## BEHAVIORAL CARE SOLUTIONS JSP20-05

Consideration at the request of Behavioral Care Solutions, for Preliminary Site Plan and Stormwater Management Plan approval. The subject property is located in Section 1, south of Fourteen Mile Road and west of Haggerty Road, and is zoned OST, Office Service Technology. The applicant is proposing to construct an addition to the existing building, resulting in a 6,329 square foot building. The applicant is seeking to continue a stand-alone drive-through ATM under a lease agreement with the previous owner and use as a bank.

# PLAN REVIEW CENTER REPORT

Preliminary Site Plan

Job No.: Sheet: 1265 SP-3

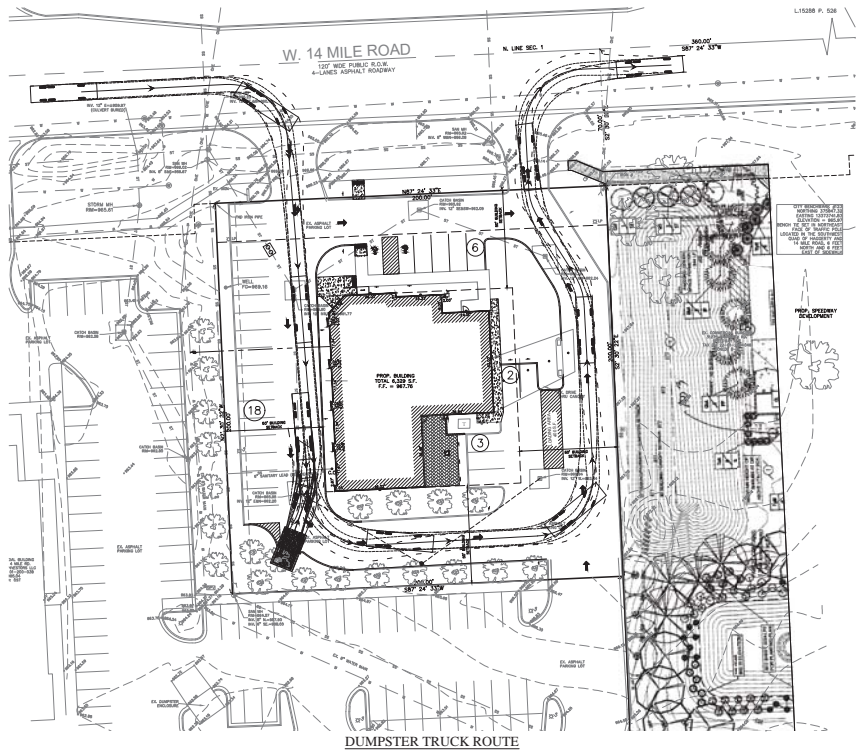
3. Bike Parking Layout (Section 5.16.6): The applicant has provided the required bicycle parking with rack detail shown on sheet SP-3. **The bicycle parking layout detail should be provided on the Final Site Plan submittal to verify conformance with ordinance requirements.**

2. Dumpster Enclosure – The dumpster enclosure indicated on Sheet SP-3 is proposed to be constructed of brick to match the building, and is full compliance with the Façade Ordinance.

3. Bike Parking Layout (Section 5.16.6): The applicant has provided the required bicycle parking with rack detail shown on sheet SP-3. **The bicycle parking layout detail should be provided on the Final Site Plan submittal to verify conformance with ordinance requirements. So noted**
